DEVELOPMENT APPLICATION ASSESSMENT REPORT

Application Number:	DA2022/0683
Responsible Officer:	Kye Miles
Land to be developed (Address):	Lot B DP 416953, 23 Chisholm Avenue AVALON BEACH NSW 2107
Proposed Development:	Alterations and additions to a dwelling house
Zoning:	C4 Environmental Living
Development Permissible:	Yes
Existing Use Rights:	No
Consent Authority:	Northern Beaches Council
Land and Environment Court Action:	No
Owner:	Christopher John Gartnell Contro Julia Caroline Pfeffer
Applicant:	Leonard William Allen
Application Lodged:	06/05/2022
Integrated Development:	No
Designated Development:	No
State Reporting Category:	Residential - Alterations and additions
Notified:	17/05/2022 to 31/05/2022
Advertised:	Not Advertised
Submissions Received:	0
Clause 4.6 Variation:	Nil
Recommendation:	Approval
Estimated Cost of Works:	\$ 538,000.00

Figure 1 - Proposed building envelope non-compliances.

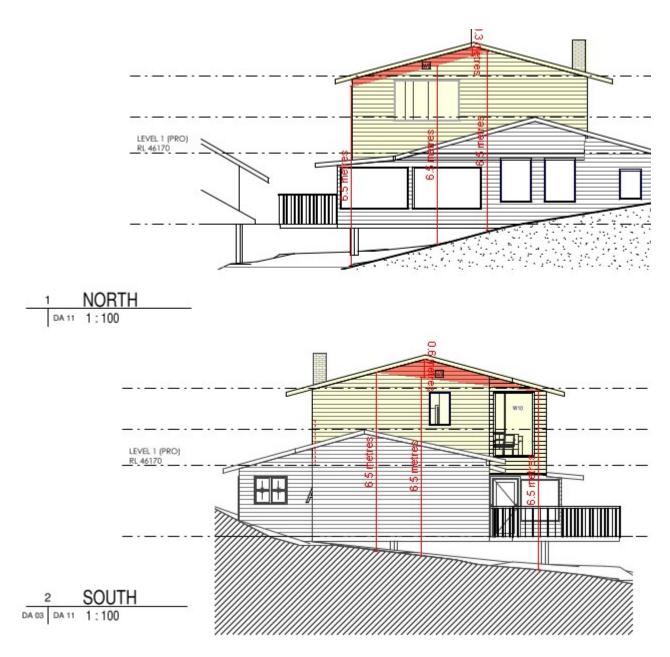
The clause stipulates that buildings are to be projected at 45 degrees from 3.5m above the existing ground level, measured from the side boundaries, but permits a variation to that envelope where the building footprint is situated on a slope of 16.7 degrees or more, which is relevant to the subject site.

The proposed development encroaches into the prescribed building envelope along both elevations. This variation is represented in red within figure 1 below.

The proposal incorporates various design elements and varied setbacks to provide visual breaks along both elevations. Overall, the proportions of the encroaching elements are not considered to be unreasonably scaled or bulky.
